# REPORT TO COUNCIL

Application: DP10-0125 / DVP10-0126

Address: 526 Doyle Avenue

Subject: Development Permit & Development Variance Permit

Appendix A: Fig. 1

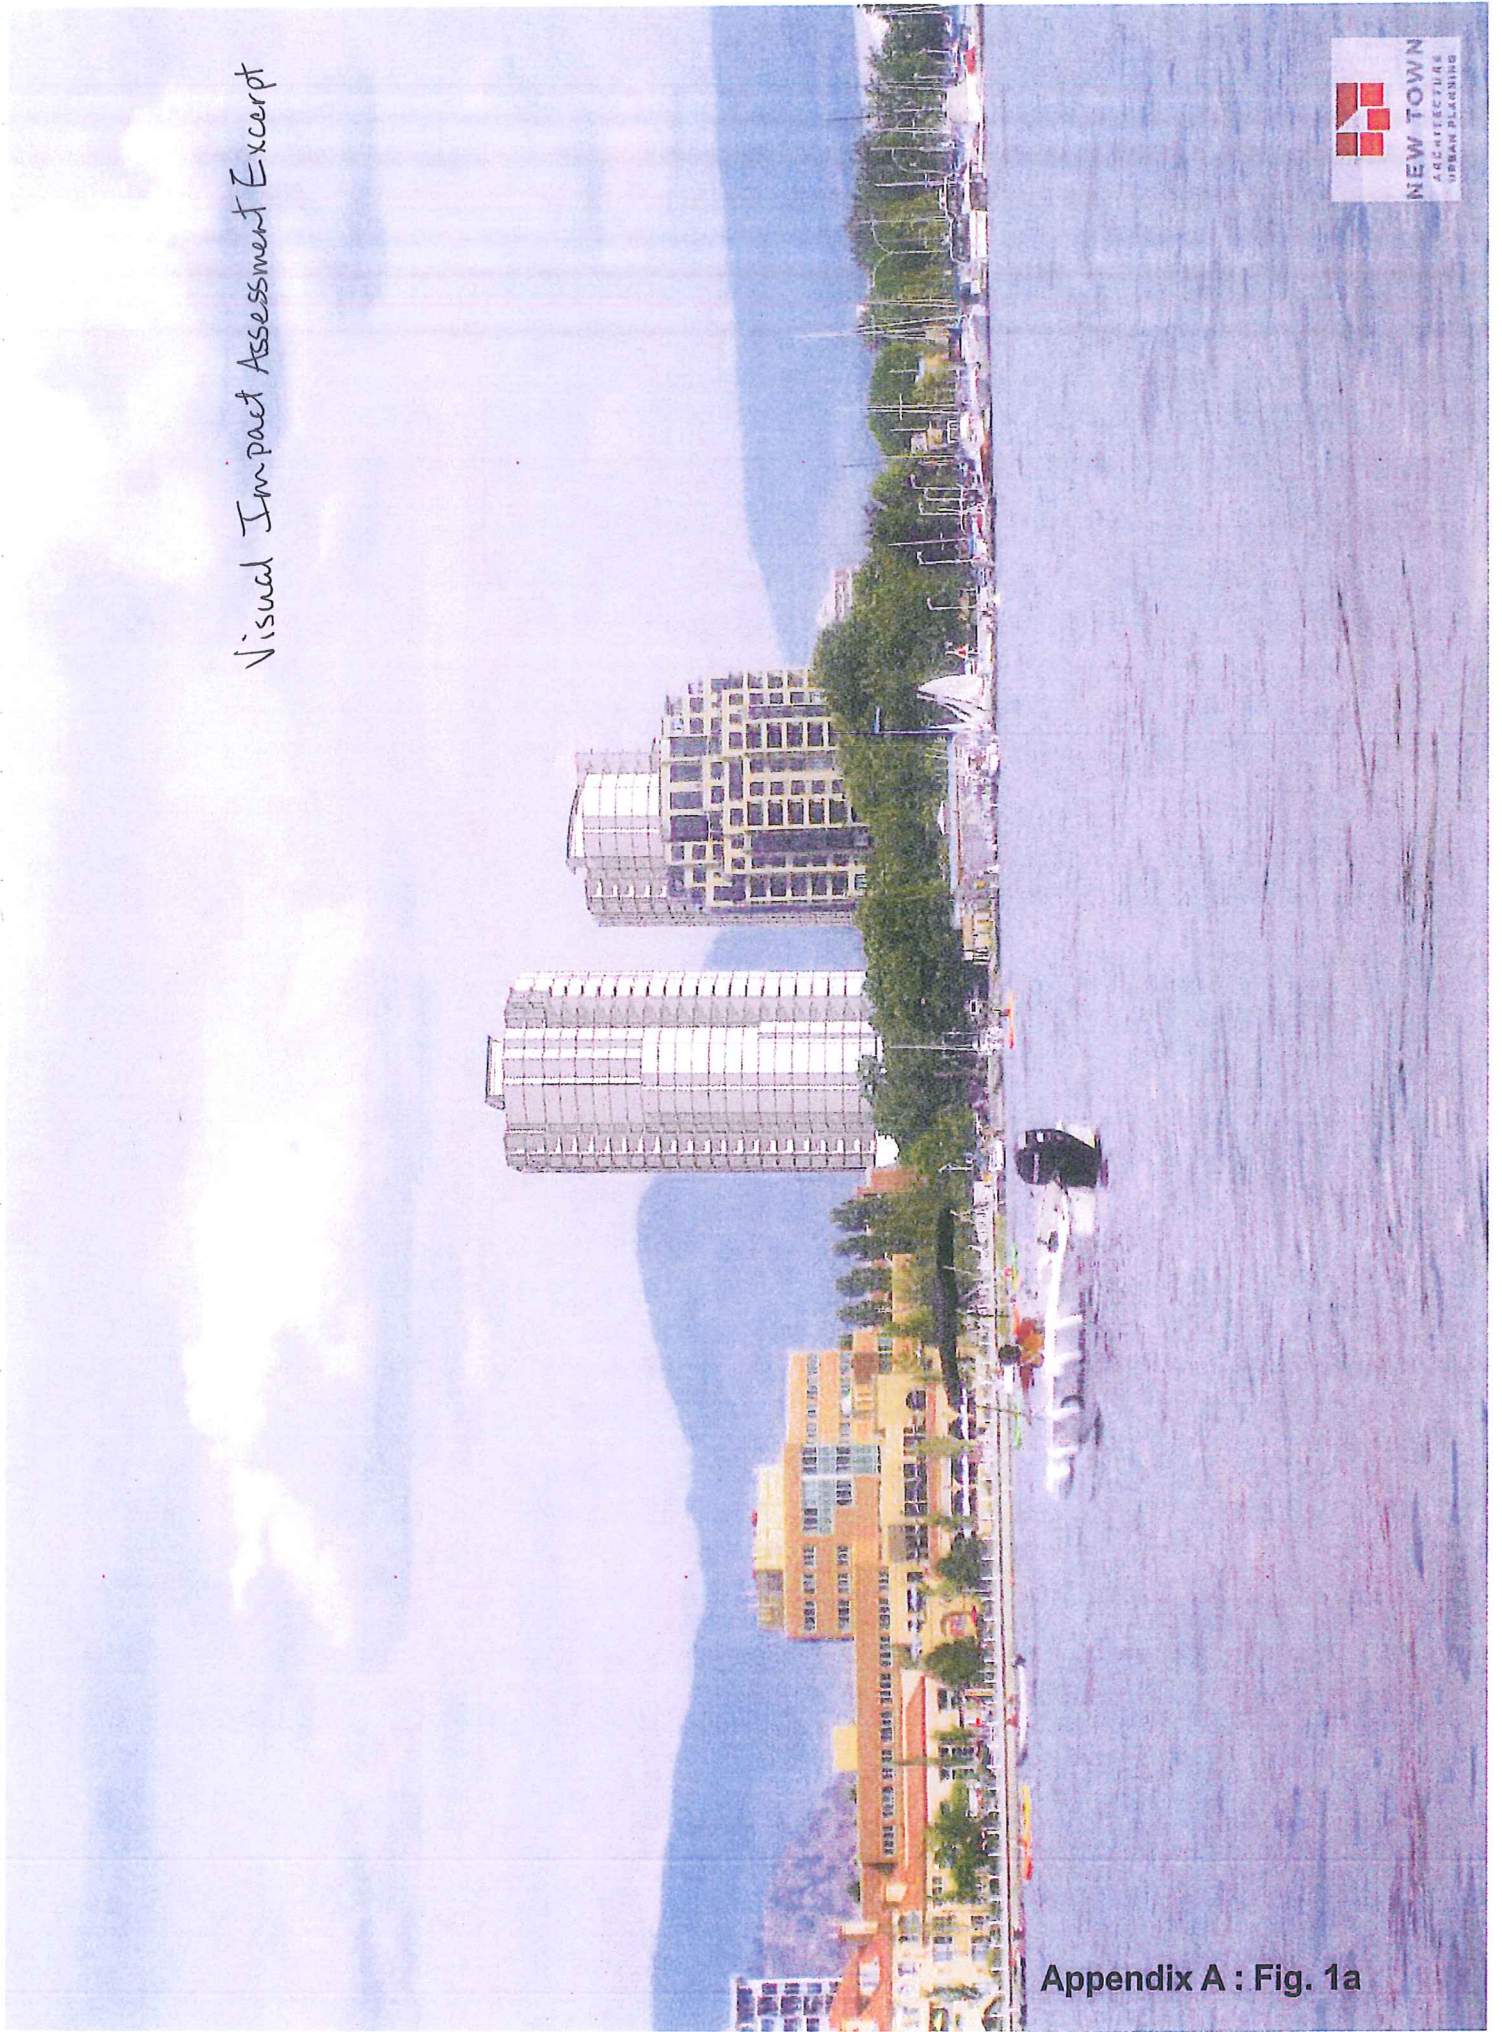
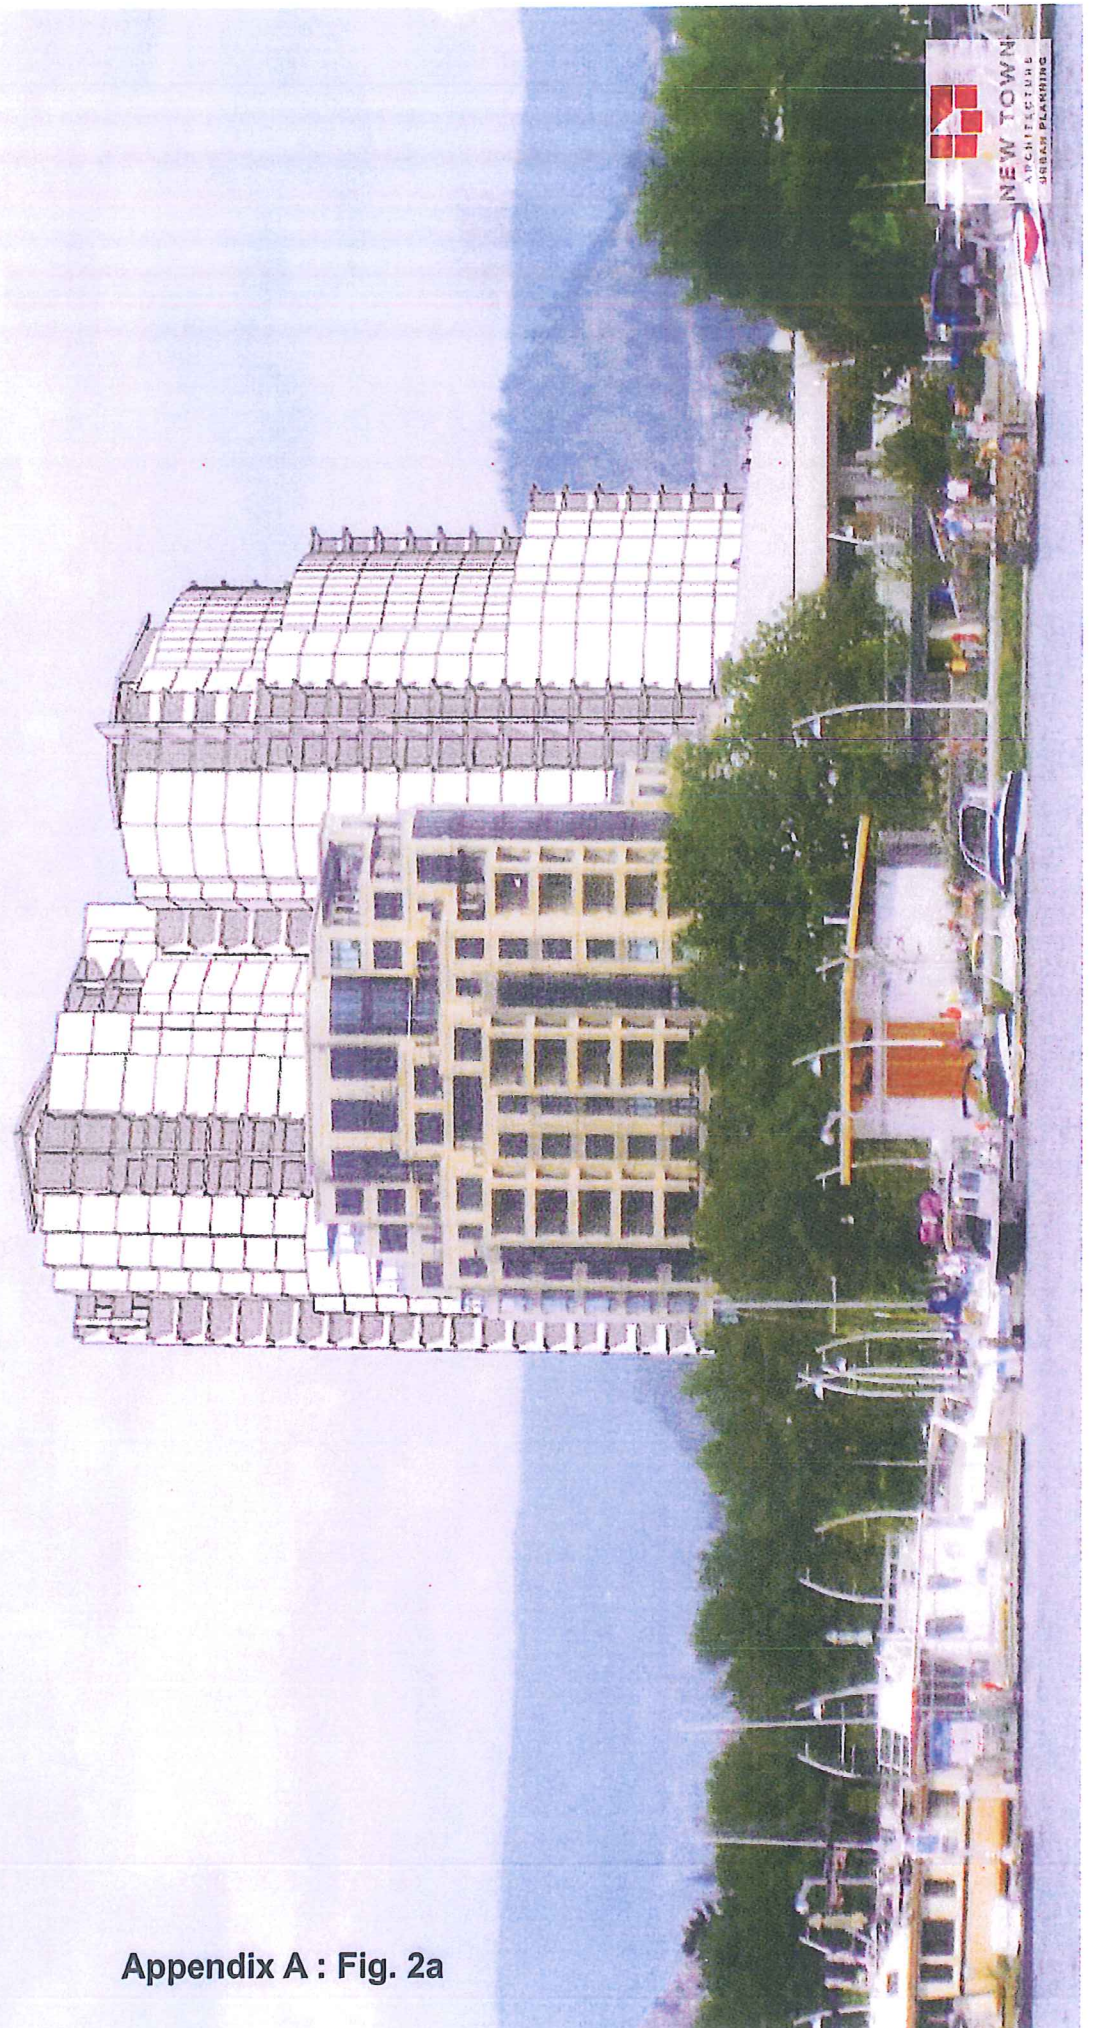
The attached Visual Impact Assessment shows how significantly the proposed development will impact the surrounding neighbourhood and the Downtown Urban Centre. The proposed development will be the largest and most visible buildings in the City. As a result of the proposed floor plate area and exterior horizontal dimension variances, both of the proposed towers are very bulky. Additionally, as only 9.3m has been proposed for the separation between the two towers, from many perspectives the buildings appear to be one large structure (see attached Visual Impact Assessment). Significant shading and wind tunnelling will also have a negative impact on adjoining properties and the public realm.
